Thrumster Wastewater Scheme Objection

Figure 2-1 Daily rainfall for the Fernbank catchment (2015-16)

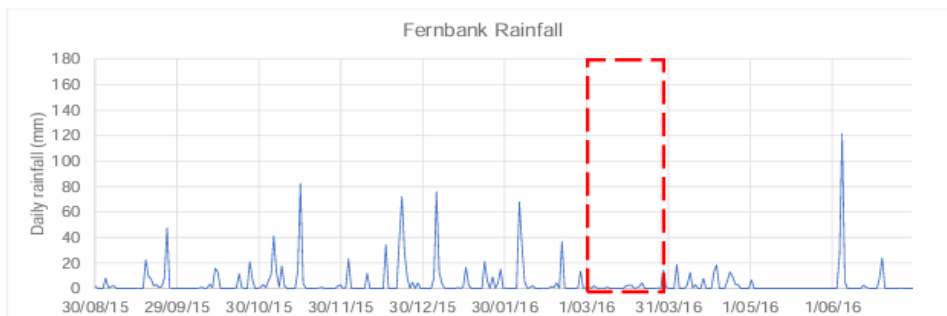
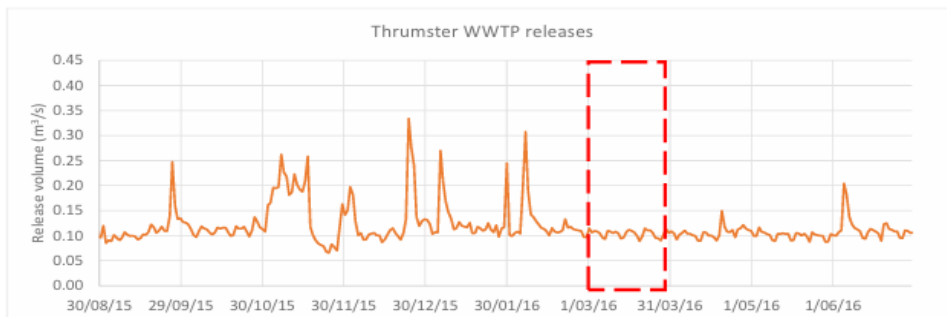
This analysis appears to rely on outdated data, using a dry-month scenario from records that are approximately nine years old I believe this is the best case scenario and modelling should have been based on worst case scenario with heavy rain periods to predict real water quality impact to the environment. More comprehensive modelling that considers recent climate trends and wet-weather events should be undertaken to ensure environmental integrity.

Appendix F Noise and Vibration

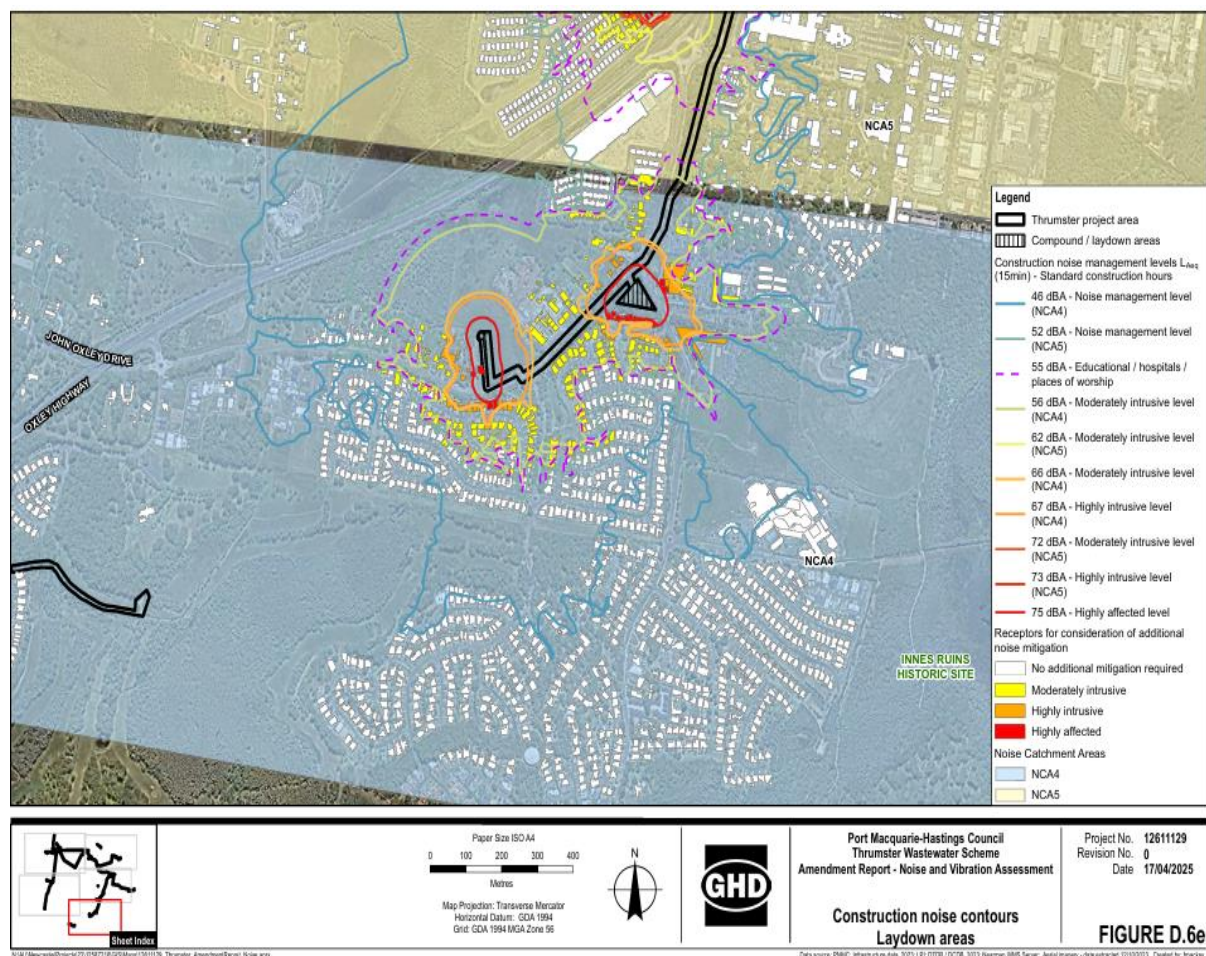
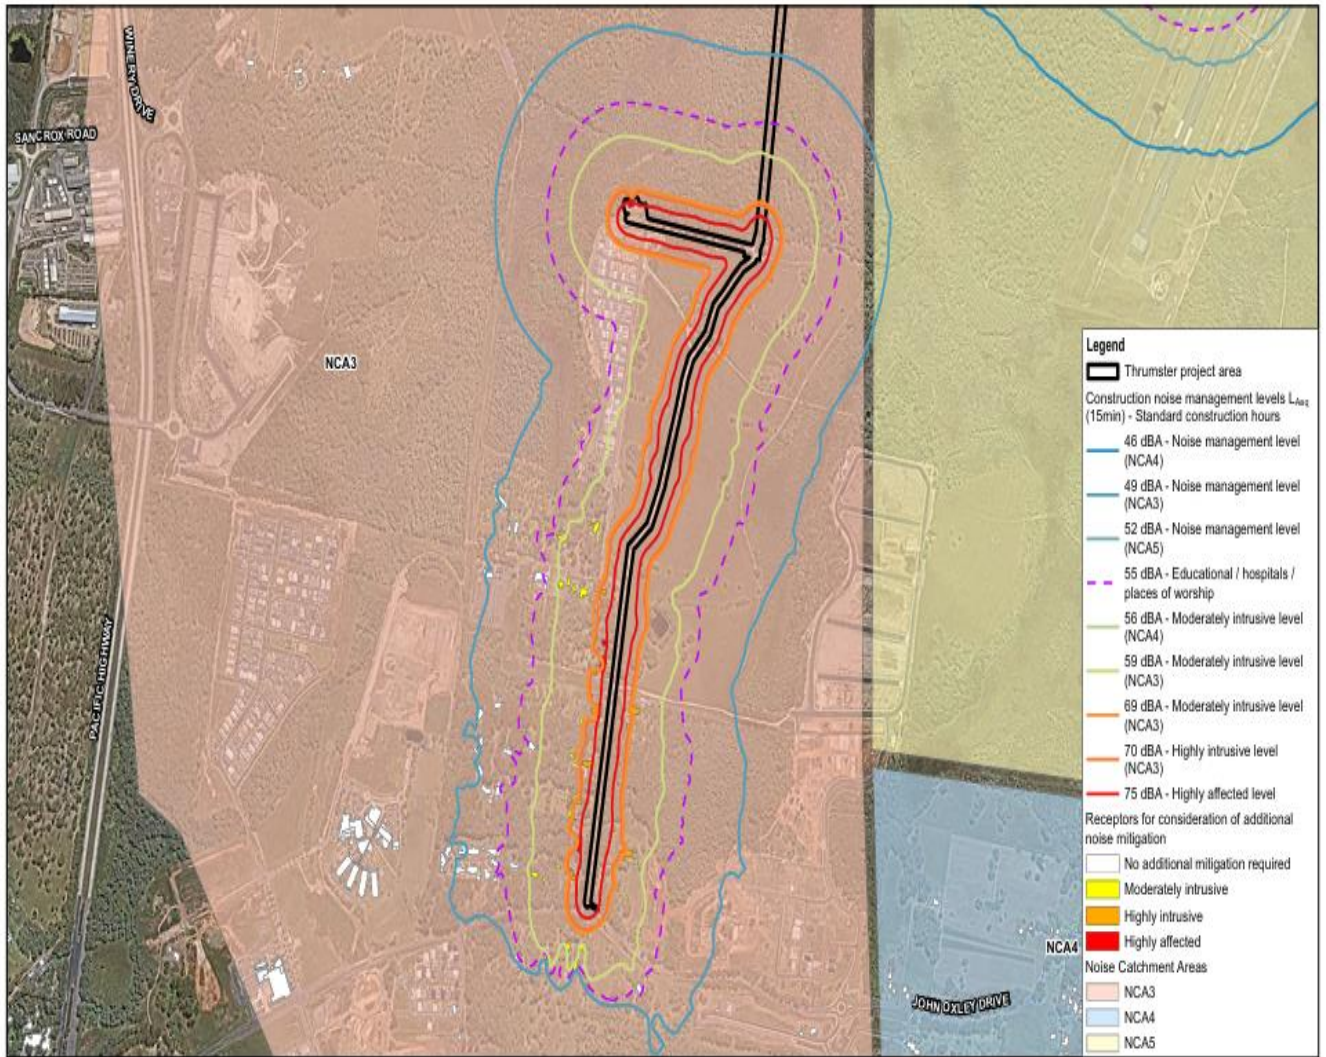
Appendix F of the Amended Report of Thrumster Wastewater Scheme contains critical data on highly impacted properties yet it appears placed at the very end from page 1399 to 1412, perhaps in the hope it would be overlooked by the uninformed impacted properties.

The maps provided in Appendix F maps (see below) are difficult to decipher due to omitted road names, making it unclear which properties will be affected. Improving transparency and accessibility of this information is essential to ensure impacted residents can properly assess the risks.

Table 24: Thrumster PAD 1 (AHIMS ID# 30-3-0390) artefact detail

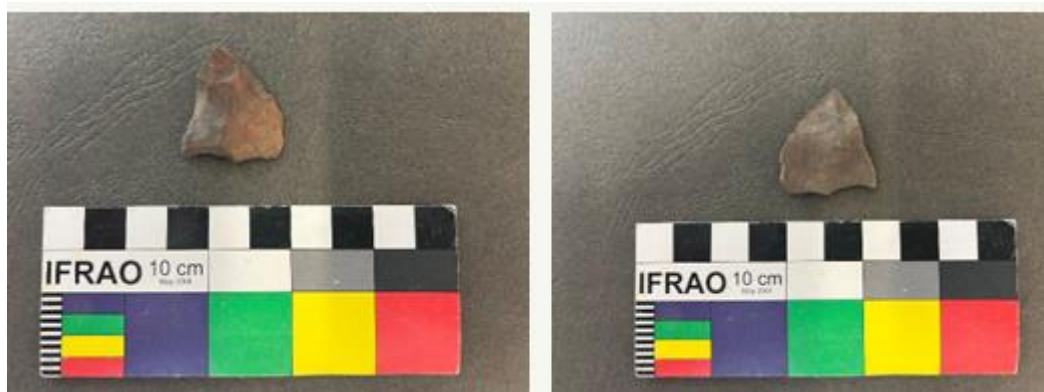
Poor visibility of 10-20 %(above) indicates this study may not been conducted thoroughly, (see Niche Report)- This suggests that **80–90% of potential artefacts may not have been identified**, raising concerns about whether cultural heritage protections were adequately upheld. The **poor survey visibility** warrants a more thorough assessment.
